Landmarks Commission

Case # SI-2018-00195

Agent	-
Applicant	Clear Vision Construction
Request	Certificate of Appropriateness for residential duplex development
Legal Description	Lot/Tract 7 & 8A
Address/Location	814, 832, 840, 844 & 848 Tijeras Ave NW
Size	0.3735 Acres
Zoning	MX-T
Historic Location	Fourth Ward Historic Preservation Overlay Zone

Summary of Project

N OVERALL SITE PLAN

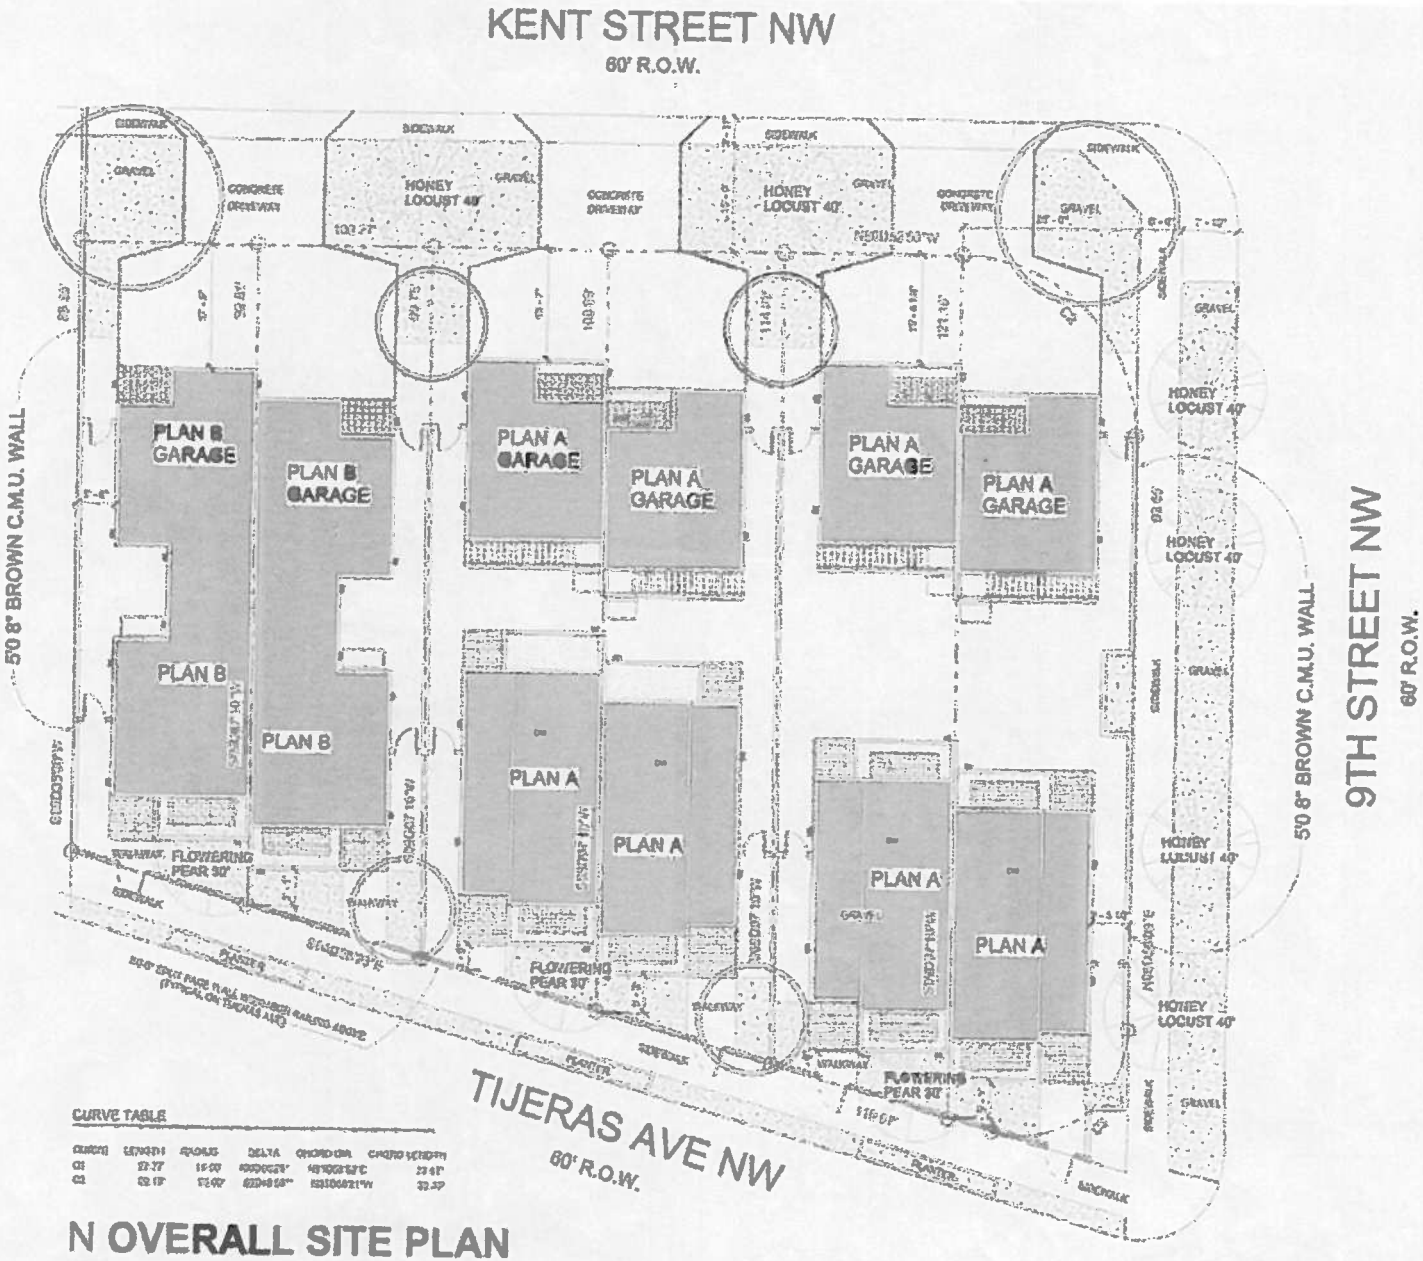
The boundary wall fronting 9th Avenue is 5' 8" high, while that fronting Tijeras Ave is 3' 8" high with a 2' railing above. However the point at which the juncture between the two forms of enclosure occurs is not identified on the site plan and approval of the project is subject to a condition requiring acceptable design details.

North Facade / Tijeras Avenue Wall & Gate detail
(Plan form A & B)

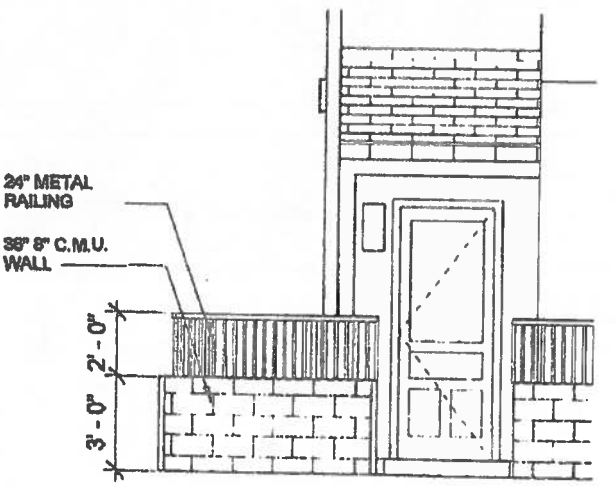
The applicant proposes 'terracotta' colored CMU walls and states that they will relate visually to the colored concrete tiles of the projecting canopies of the buildings. The proposal is thus contrary to the requirement for CMU walls to be stuccoed and the Commission should decide whether the deviation is acceptable in this case.

4. CMU garden walls shall be stuccoed.

East Facade (facing parking lot)
Plan form B

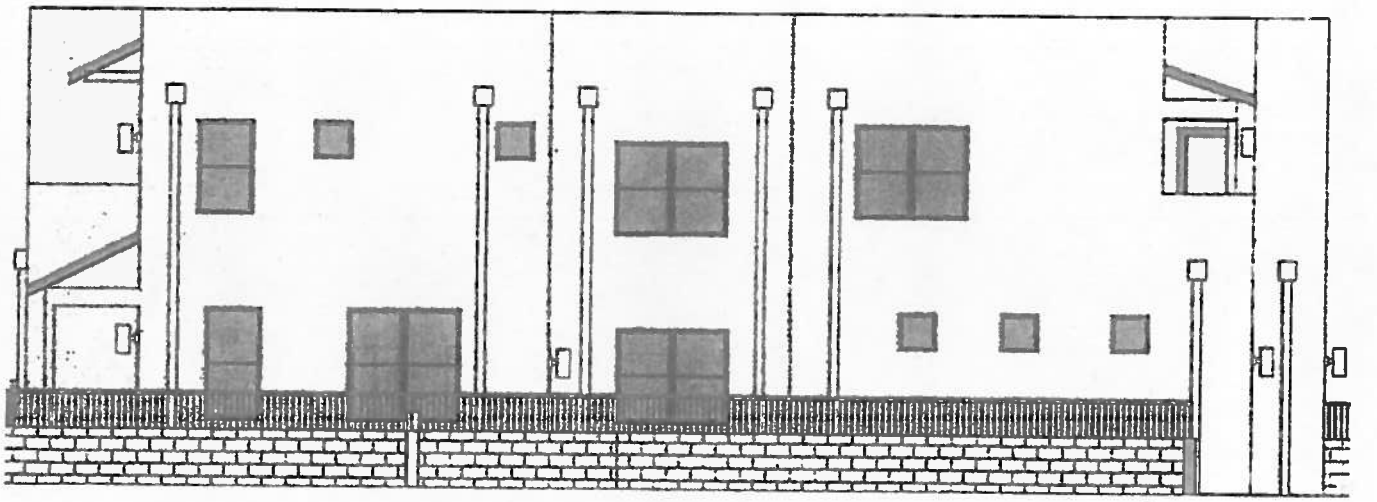
Note: this visual incorrectly illustrates the boundary wall. The eastern boundary of the site is to be enclosed by a CMU wall 5' 8" high

West Facade / 9th Street
(Plan form A)

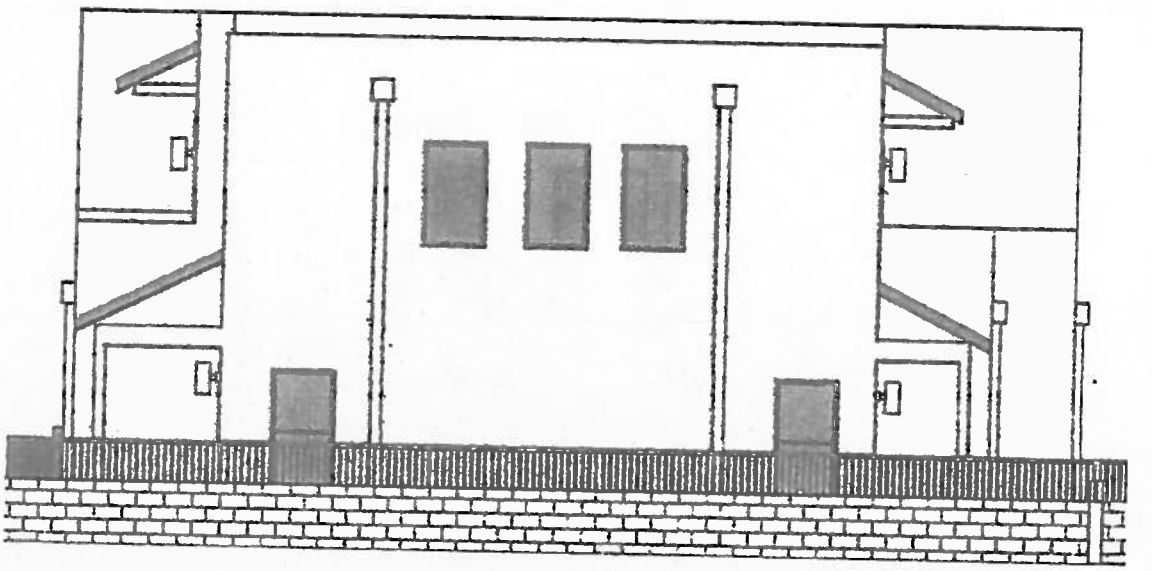
The side facades of the western-most unit of the new development front 9th Street. While the western facades are articulated to some extent, they are nevertheless inactive and present a 'closed' appearance to the street. Historic buildings enclosing 9thStreet typically have active frontages that are accessible to pedestrians and in this context, the impermeable, inactive side facades of the new development appear somewhat alien. While this may not cause actual harm to the special qualities of the Historic District as a whole, a more sensitive design approach could result in greater enhancement of the streetscape.

Note: this visual incorrectly illustrates the boundary wall. The 9th Street boundary is to be enclosed by a CMU wall 5' 8" high

West Facade / 9th Street - Garage/Studio
(Plan form A)

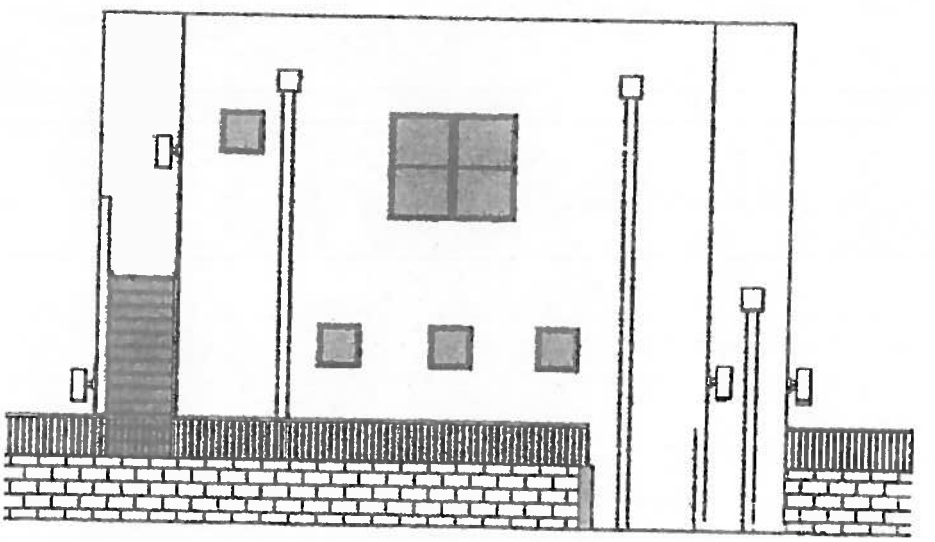
Note: this visual incorrectly illustrates the boundary wall. The 9th Street boundary is to be enclosed by a CMU wall 5' 8" high
